A303 Sparkford to Ilchester Dualling Scheme TR010036

8.8 Draft Statement of Common Ground with Defence Infrastructure Organisation

DRAFT STATEMENT OF COMMON GROUND

Pond 4

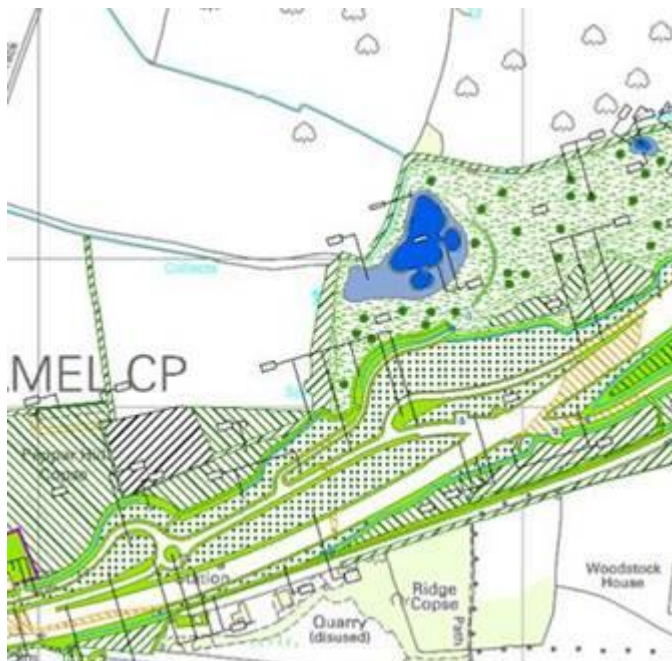
- 3.1.1 The Defence Infrastructure Organisation (DIO) is concerned that the proposal to construct six ponds which will contain permanent bodies of water could attract birds to the area and increase the risk of bird-strikes.
- 3.1.2 An assessment has been undertaken to assess the risk of bird-strikes, which is summarised below.

3.3.3 These ponds are generally sheltered and do not provide open views of the countryside except for the pond 4 that has open views to the south.

- There are limited records of problem bird species in the area;
- Ponds are generally sheltered apart from pond 4, which may require some additional measures.
- Adjacent road noise is likely to deter birds; and
- There will be no public access to these ponds to eliminate possible bird feeding.

- The planting adjacent to Pond 4 will be reviewed.
- Further discussion with the DIO's bird-strike safeguarding team would be useful.
